TECHNICAL INFORMATION

Date: 04.05.2022
TI: 0422
Machine type/s: HG/HO

Vane pump for HG and HO machines

Alternative vane pump

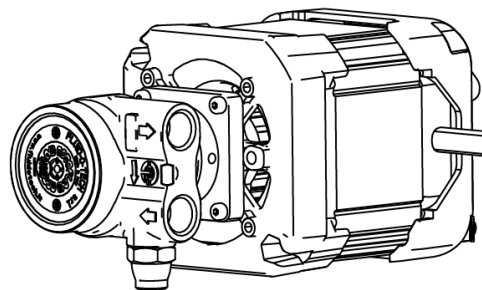
Due to supply issues experienced worldwide there has been a shortage of a key component. To maintain the supply chain, as a temporary measure we will be fitting an alternative vane pump.

The alternative vane pump with a stainless steel head is also from Fluid-o-Tech and has been tested extensively in the laboratory. Performance data with regard to pressure gradient and volume conveyed by the pump is identical to the original. Furthermore it works extremely well in our equipment.

From **production week14** and **serial number 90532378** the alternative pump will be fitted in the following machine type:

- Siamonie Series ES/IN
- SiVend HG15 TT ES/ IN
- HG floor-standing machines - Series ES/IN
- SiVend HG20 Trend ES/ IN

Part number: 985.27.937.00

If the part needs replacing both pumps are compatible so the original pump can be retro-fitted without any problem. The alternative pump is not being supplied as a spare part.
